10 Mb/s Single Twisted Pair Ethernet

10BASE-T1L EEE

(Comments #574, #575, #579, #582)

Comment #575: Link Monitor

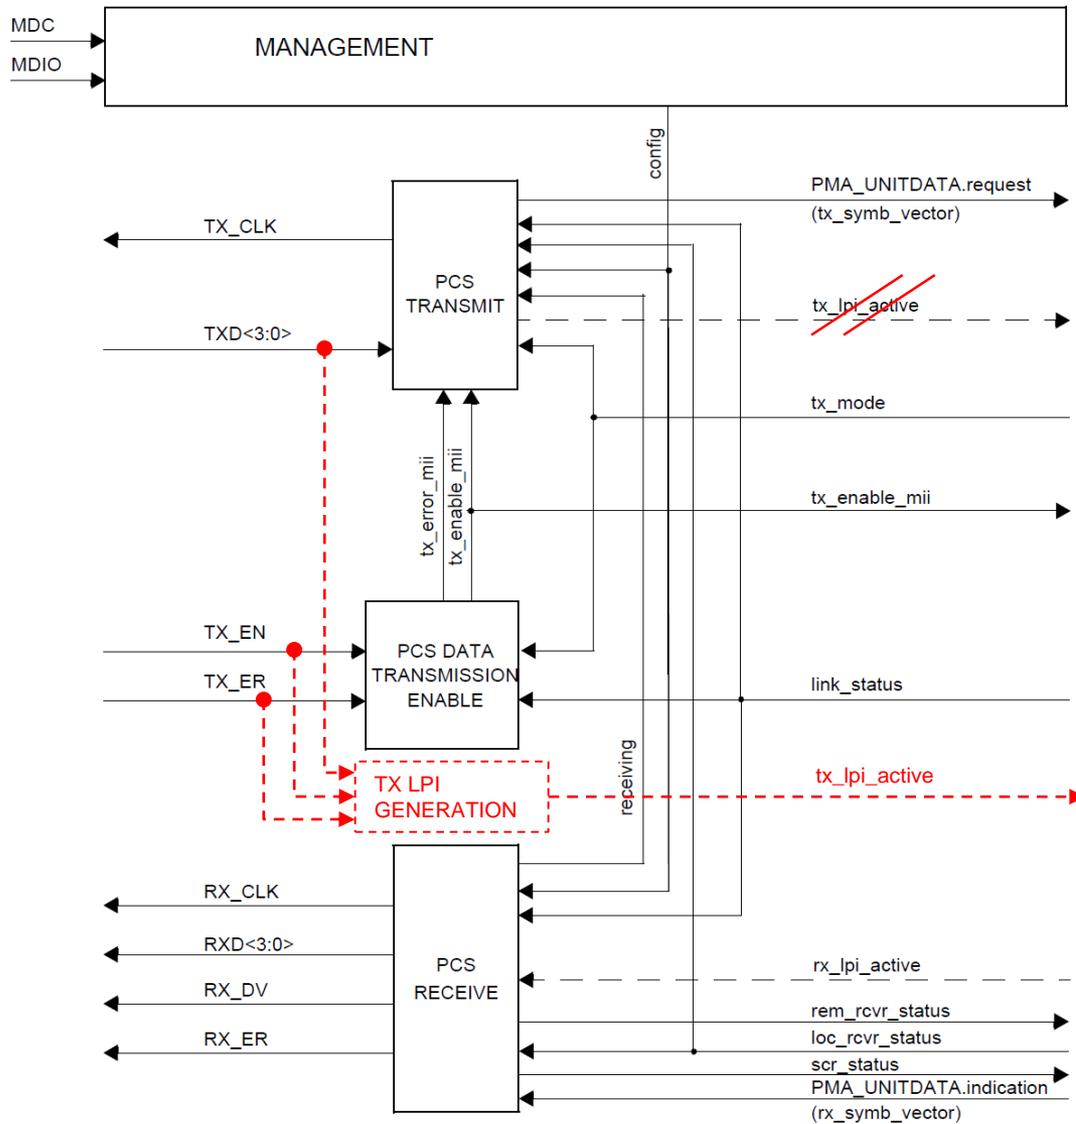
- The Link Monitor state diagram as in draft D2.0 will unintentionally generate a link down, when being in QUIET state.
- This is prevented by adding `(loc_lpi_req = FALSE)` condition as shown above, as the variable `loc_lpi_req` is TRUE in this case (while LPI mode is active).

Comment #579: PCS Reference Diagram

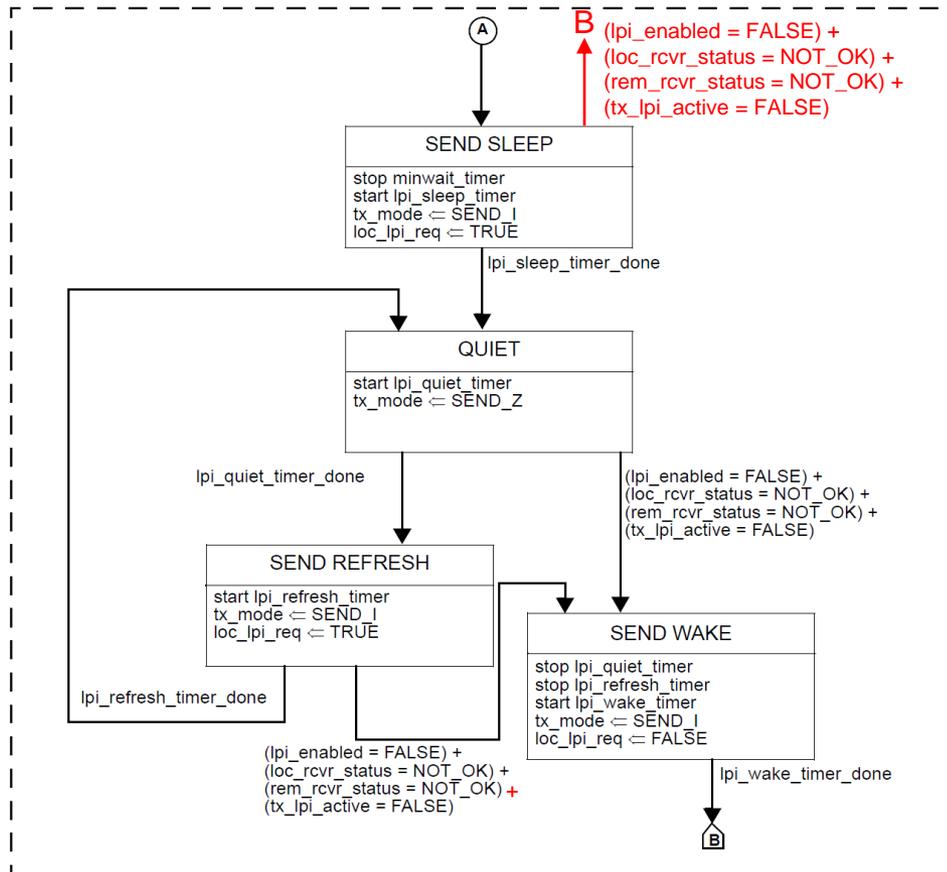
According to the description of variable `tx_lpi_active`, this variable is set to TRUE, if „Assert Low Power Idle“ condition on the MII is active.

Figure 146-3 shows the variable being generated within PCS TRANSMIT, which does not directly get the control signals from the MII.

To match Figure 146-3 to the intended functionality of `tx_lpi_active`, a new functional block „TX LPI GENERATION“ should be added, which directly gets the signals from the MII.
